## City of Everett ADA Transition Plan

July 2018

## Recreation Center

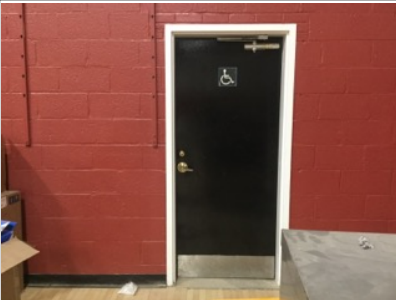
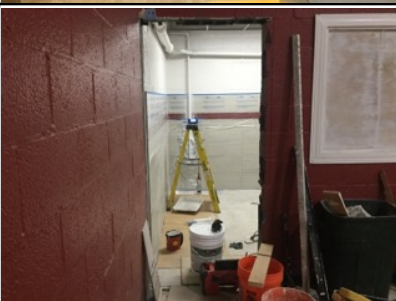
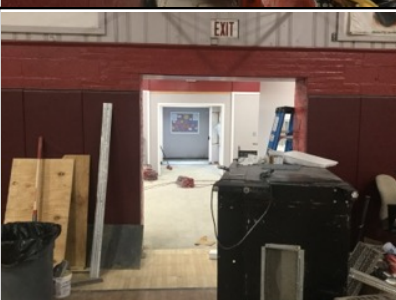
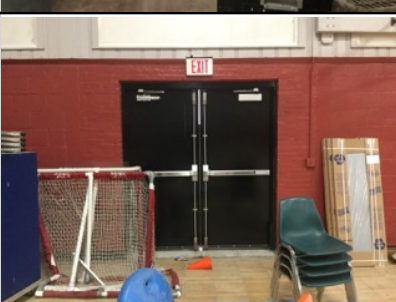
ID	Location	Floor	Room	Element	Type	Photo	Issues	Current Measure	Recommendations	Quantity	Price	Cost Estimation
<b>Approach and Entrance</b>												
<b>Entrance</b>												
1	Entrance to Building	Ext.		Entrance	Entrance		Automatic door opener not operable	16 lbs	Repair or replace the door opener.	1	1530	\$1530
<b>Emergency Exit</b>												
2	Western Exit in Gymnasium	1		Emergency Exit	N/A		Emergency exit not on an accessible route Threshold > 3/4" high	- 6.5"	Provide a directional sign indicating the location of the nearest emergency exit.	1	116	\$116
3	Northeastern Exit in Gymnasium	1		Emergency Exit	N/A		Threshold > 3/4" high	2.5"	Alter threshold to be 3/4" high max.	1	125	\$125
<b>Access to Goods and Services</b>												
<b>Interior Access Route</b>												
4	Men's Accessible Toilet Room	1		Interior Access Route	N/A		Obstructed by protruding objects	8.5"	Relocate dispenser out of the circulation path.	1	153	\$153

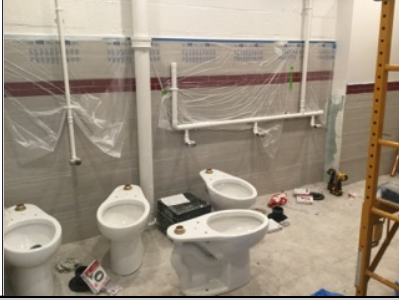
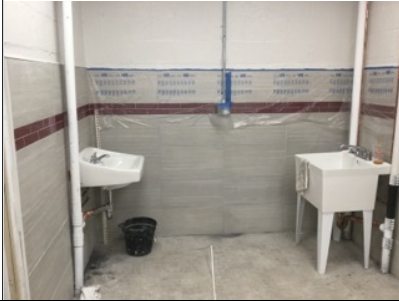
8	Southern Exit in Gymnasium	1		Ramps	Exterior		Handrails not provided at both sides if rise is > 6"	9"	Provide handrails on both sides.	2	407	\$814
<b>Stairways</b>												
9	Stairway to Lot From Elm St.	Ext.		Stairways	Exterior		Handrail not provided on both sides	-	Provide handrails on both sides.	2	555	\$1110
